**County of San Diego
Planning & Development Services
BUILDING DIVISION**

ACCESSIBILITY CORRECTION LIST Multifamily Housing	2A
Parking Facilities

**FIGURE 11A-2B
SINGLE AND VAN ACCESSIBLE PARKING STALLS**

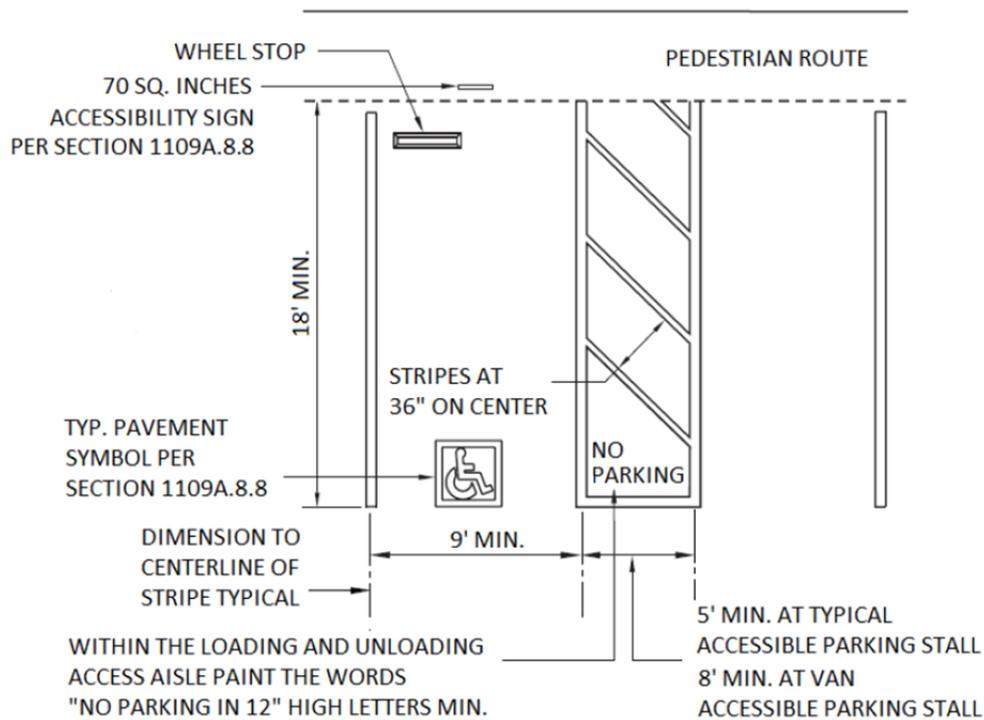
- 13. Provide complete dimensions and coordinated detailing for each accessible parking space. *CBC 1109A.8*
- 14. Where individual accessible parking spaces are provided, dimension the following per CBC Figure 11A-2B:
 - Standard accessible parking spaces:
 - Minimum 9-foot-wide by 18-foot-long parking stall with minimum 5-foot-wide by 18-foot-long parking stall located adjacent to either side of parking stall
 - Van accessible parking spaces per **one of the following:**
 - Minimum 12-foot-wide by 18-foot-long parking stall with minimum 5-foot-wide by 18-foot-long access aisle located on passenger side of parking stall with the vehicle parked in the forward position
 - Minimum 9-foot-wide by 18-foot-long parking stall with minimum 8-foot-wide by 18-foot-long access aisle located on passenger side of parking stall with the vehicle parked in the forward position

**FIGURE 11A-2A
DOUBLE PARKING STALLS**

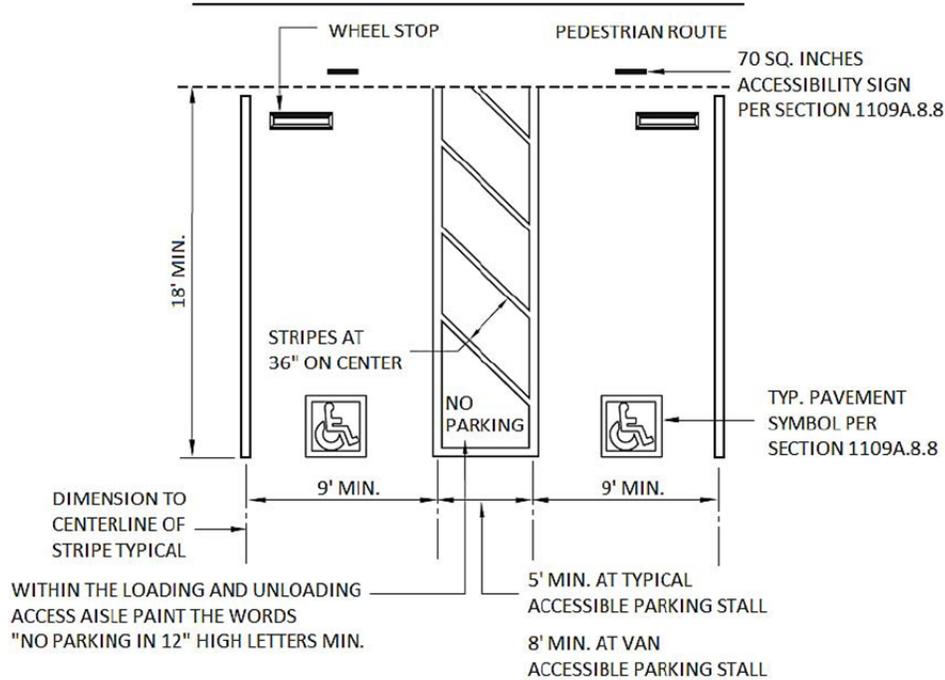
15. Where dual accessible parking spaces are provided, dimension the following per CBC Figure 11A-2A or CBC Figure 11A-2C:

- Two minimum 9-foot-wide by 18-foot-long parking stalls
 - Minimum 5-foot-wide by 18-foot-long access aisle between parking stalls
- Exception:** Minimum 8-foot-wide by 18-foot-long access aisle required on passenger side of van accessible spaces

FIGURE 11B-705.1
 SIZE AND SPACING OF TRUNCATED DOMES

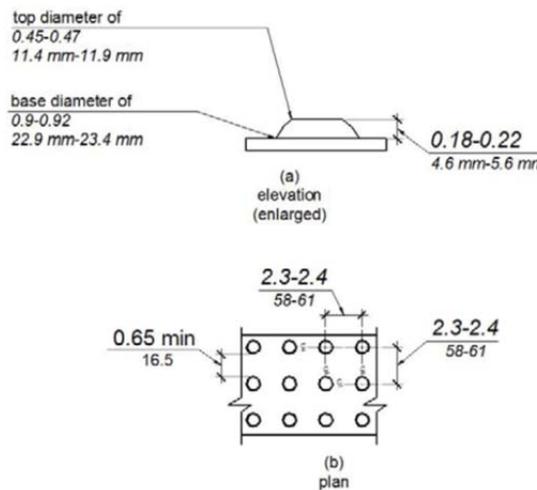
20. At pedestrian ways entering or adjoining parking stalls or access aisles without curb, railing, or barrier separation, detail continuous detectable warning strip complying with the following:

- 36-inches (absolute) deep for entire length/width of transition
 - Including raised, truncated domes per CBC Figure 11B-705.1:
 - o Minimum 0.9-inch and maximum 0.92-inch base diameter

- o Minimum 0.45-inch and maximum 0.47-inch top diameter
 - o Minimum 0.18-inch and maximum 0.22-inch height
 - o Minimum 2.3-inch and maximum 2.4-inch center-to-center spacing and minimum 0.65-inch base-to-base spacing**Exception:** Minimum 1.6-inch and maximum 2.4-inch center-to-center spacing acceptable for domes in radial pattern

- Yellow color – integral to surface – conforming to FS33538 of Federal Standard 595C
